Access Compliance Report Public Rights-of-Way (Curb Ramps)

Intersection ID: 11512 Main Street: N_SMITH_ST Cross Street: W_7TH_ST Location: W

ADA ID: AD09DB3FE3BA Ramp Type: PerpDiag Initial Pass/Fail: Fail Overall Compliance: No Severity Score: 27.5

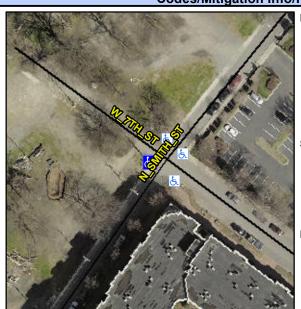
R304.5.3, R302.7

Compliance Description		Data	Comp	liance	Description	Data
N/A	Ramp Length (in)	62.0	Yes	Ramp	Slope (%)	5.4
Yes	Ramp Width (in)	55.0	No	Ramp	XSlope (%)	5.4
N/A	Flare Type LT	N/A	N/A	Flare	Type RT	N/A
N/A	Flare Slope LT (%)	N/A	N/A	Flare	Slope RT (%)	N/A
N/A	Flare Traversable LT?	N/A	N/A	Flare	Traversable RT?	N/A
N/A	Landing Length (in)	N/A	N/A	DWS	Provided?	N/A
N/A	Landing Width (in)	N/A	N/A	DWS	Contrast?	N/A
N/A	Landing Slope (%)	N/A	N/A	DWS	Length (in)	N/A
N/A	Landing X Slope (%)	N/A	N/A	DWS	Full Width?	N/A
N/A	Landing Curb? (Y/N)	N/A	N/A	DWS	Offset (in)	N/A
N/A	Shared Landing?	N/A				
N/A	Gutter Ponding?	N/A	N/A	Gutte	r Slope (%)	N/A
N/A	Gutter Lip Ht (in)	N/A	N/A	Gutte	r X Slope (%)	N/A
N/A	Painted X Walk1?	No	N/A	Painte	ed X Walk2?	No
	X Walk 1 Direction	To SE		X Wa	lk 2 Direction	To NE
N/A	X Walk 1 Width (in)	N/A	N/A	X Wa	lk 2 Width (in)	N/A
	X Walk 1 Slope (%)	5.1		X Wa	lk 2 Slope (%)	3.2
	X Walk 1 X Slope (%)	0.1		X Wa	lk 2 X Slope (%)	1.0

Poor

Remove & Replace Curb Ramp With
Two New Directional Ramps or
Equivalent.
